Subject:
 RE: CON #6085 RS

Re: Arnold Senior Living, LLC, CON Application #6085RS

I am writing in support of Arnold Senior Living, LLC's proposed plan for the construction of a new assisted living facility near the intersection of Vogel Rd & Old Lemay Ferry Rd, Windsor Township, MO 63010 in a suburb of the city of Arnold, MO.

FIRST FLOOR PLAN -

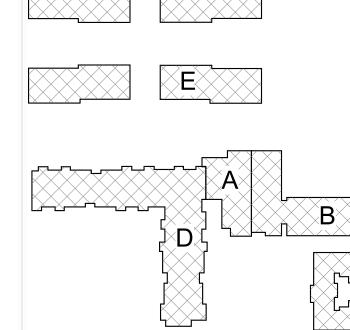
- Can you provide a more divided detail sheet? I am having trouble figuring out what costs go where.
- The utilization projections provided in Divider II, #12 show 48%, 86%, and 92% for years 2027-2029; however on the Revenues and Expenses form I calculate utilization to be 23%, 72.3%, and 87.01%. Since patient days were not provided in divider two, I am unable to determine the discrepancies.
- Provide cleaner schematics with semi-private and private labels.
- Were cents included on the revenues and expenses form?

- 3. Attached are additional schematics that distinguish between private and semi-private rooms.
- 4. Revenues and expenses were rounded to the nearest dollar before being added to the revenues and expenses form.
